PERMIT

SEWAGE DISPOSAL SYSTEM

SUBDIVISION Mooresfield ROAD 7549 Cherry Tree Drive OT 15, Blk. C,
Sec. 1

Proposed Addition
 (2 Car Garage + Future Living Space)

LIBER	FOLIO	HOUSE LOCATION FOR	7/14/81
BEING KNOWN AS LOT 15 BLOCK 6 SECTION 1 GREAT		1012 CHERRY TREE DRIVE	
AS SHOWN ON A PLAT ENTITLED PLAT ONE		HARVARD COUNTY, MARYLAND	
RECORDED IN THE LAND RECORDS OF		CASE NO.	
PLAT BOOK		NO.

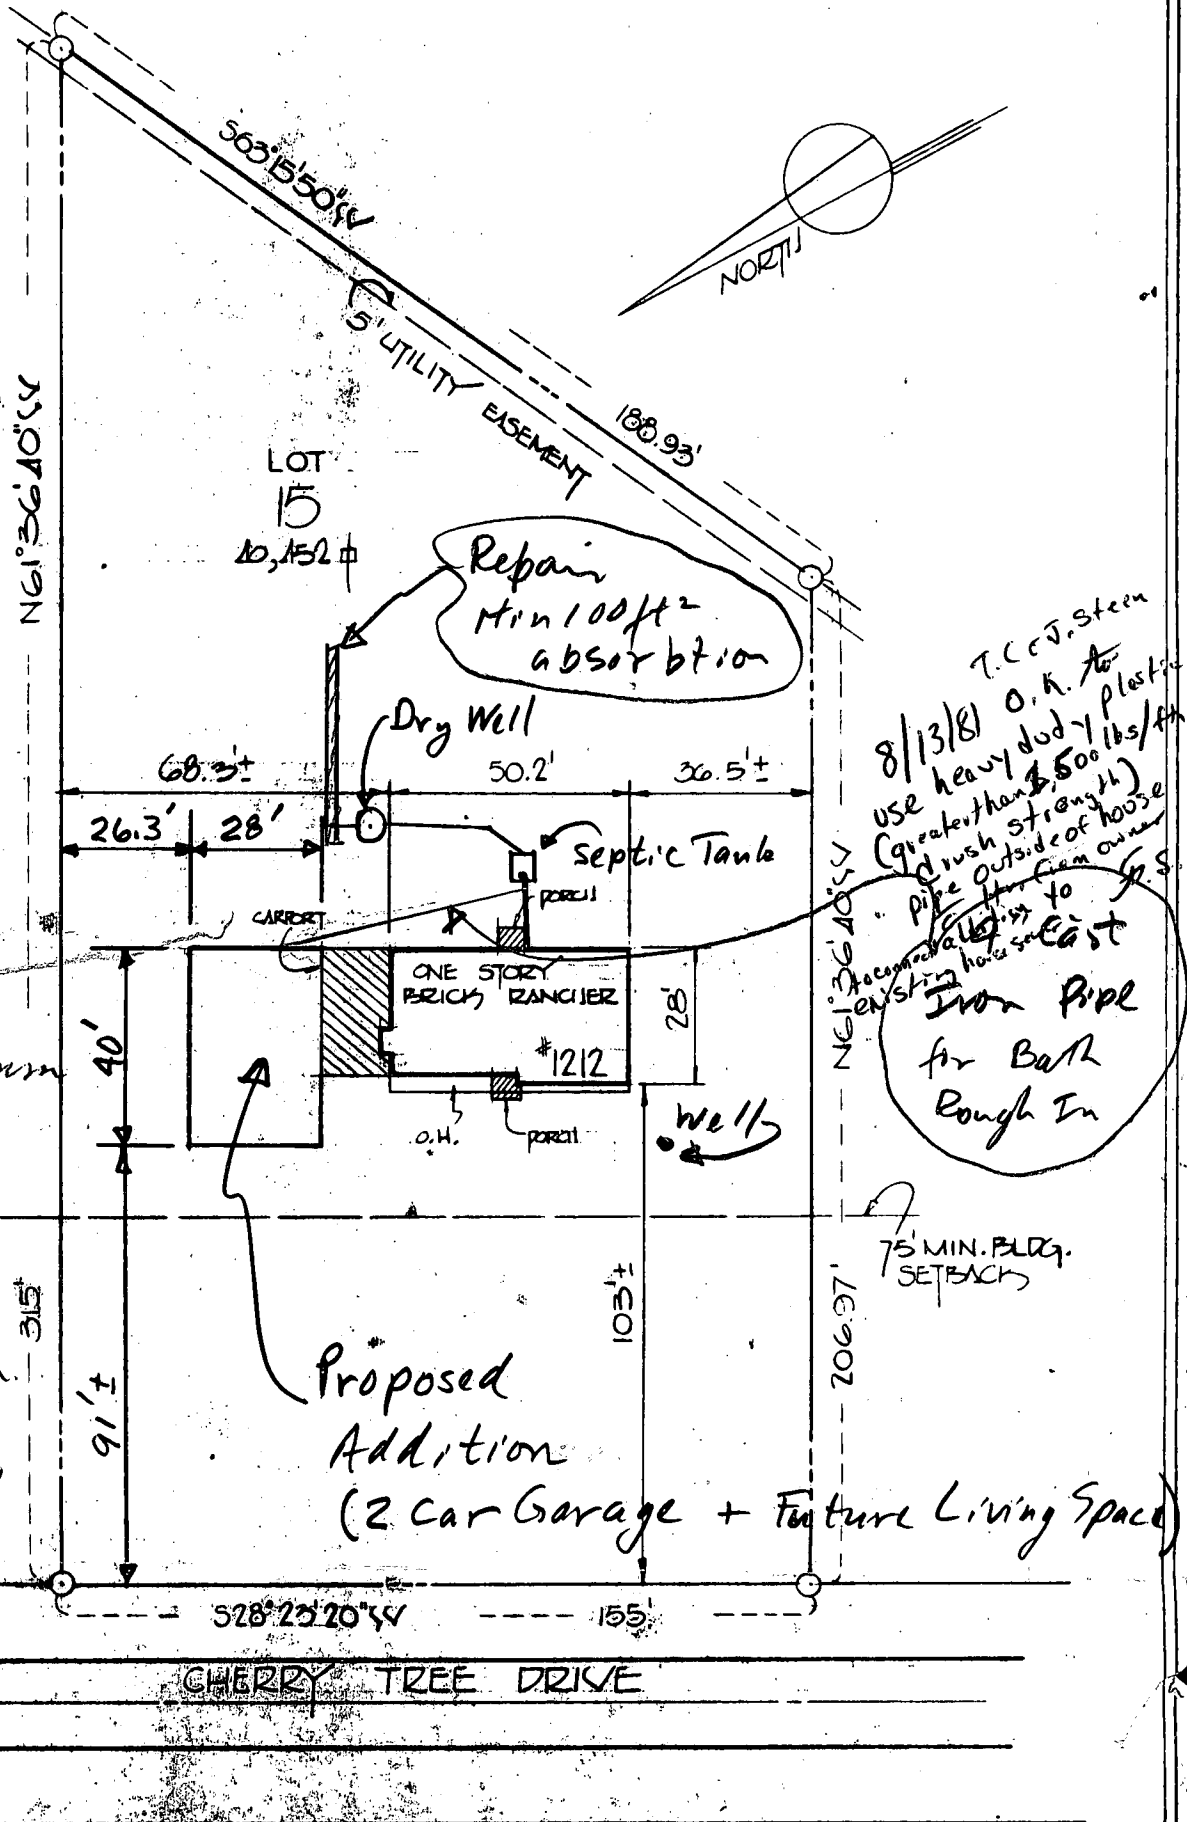
8/13/81 T.C.C.J. Stein
 use heavy duty plastic
 (greater than 500 lbs/ft²)
 (rush strong H)
 pipe outside of house
 from main sewer
 to
 existing hole in east
 Iron Pipe
 for Bath
 Rough In

7/30/81
 Sketch O.K.
 G.P.S.

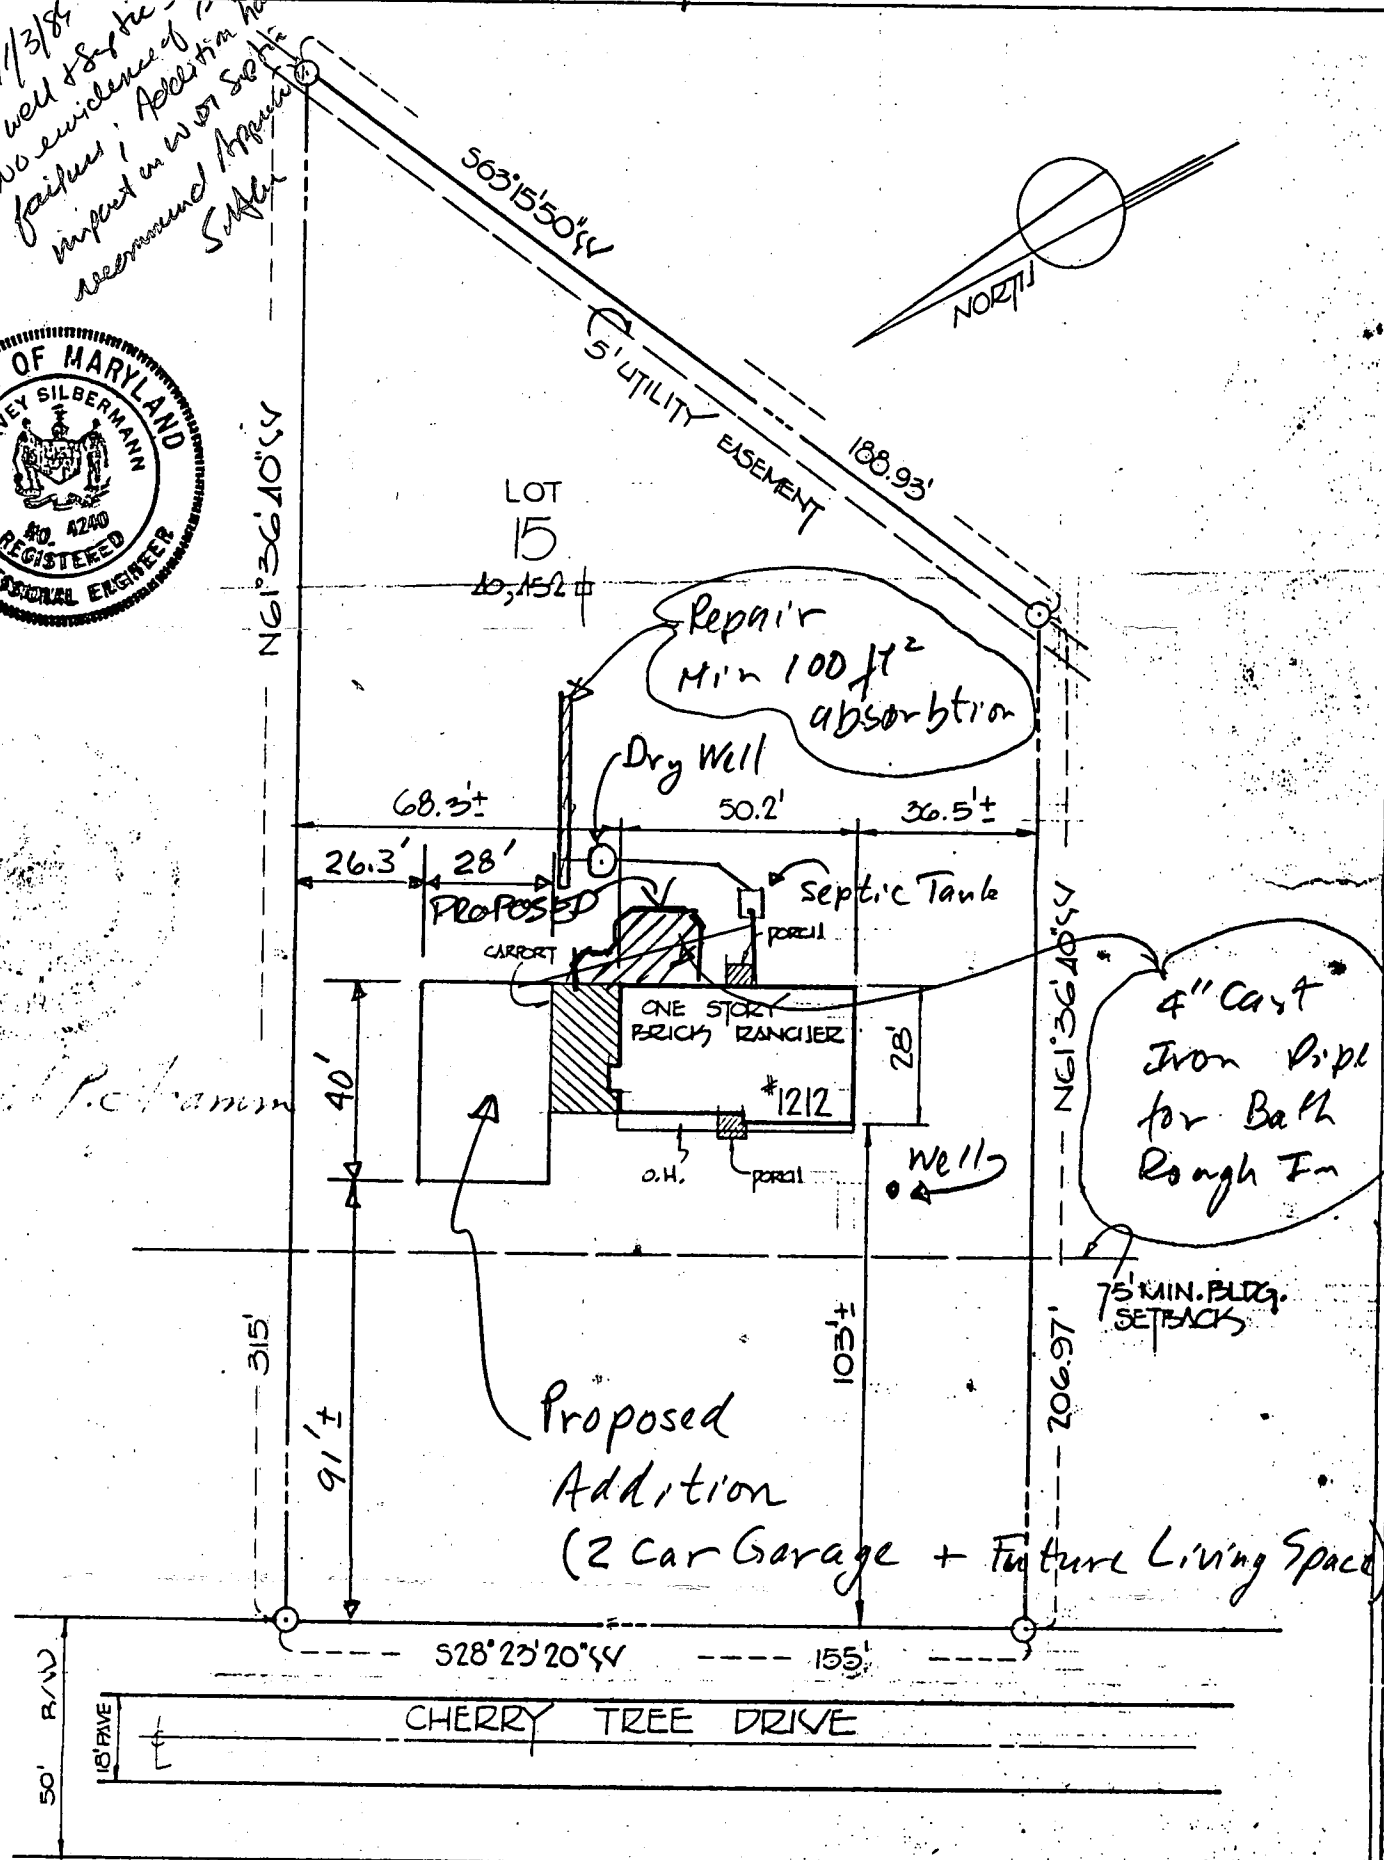
*11/3/81
well & Septic located
no evidence of septic
failure; Addition has no
impact on water supply
recommended Approval
Satisfied*
